REQUEST

SUMMARY OF PETITION

The petition proposes to combine four apartment buildings into two buildings without an increase the number of dwelling units. The site is currently developed with two new structure-parked apartment buildings and 17 gardenstyle apartment buildings dating from the 1960s.

PLANNING STAFF REVIEW

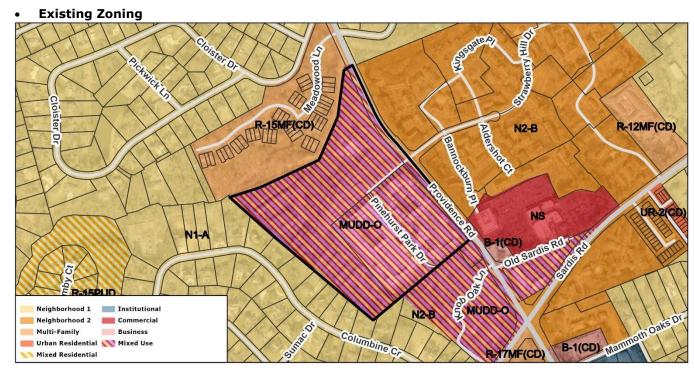
The site plan amendment contains the following changes:

- Combines four apartment buildings, Buildings 1, 2, 4, & 5 as shown on the site plan associated with previously approved Petition 2019-047, located along Private Street A (Pinehurst on Providence Drive) into two larger apartment buildings, Buildings 1 & 2, on the proposed site plan.

- The combination of buildings would not increase the overall unit count of 830 as prescribed by the previous approval, Petition 2019-047.
- Increases the height of Building 2 (combination of Buildings 4 & 5 from the previous approval), from 2 stories to 3 stories.

- Relocates the proposed amenity area, as approved by the October 2023 Administrative Amendment to Petition 2019-047, farther from the western property Boundary adjacent to properties along Columbine Circle.

- Reconfigures the urban open space located at the intersection of Private Street A and Private Street B (Pinehurst on Providence Drive and Pinehurst Parkway).

- Realigns greenway dedication to Mecklenburg County Park and Recreation through the site.
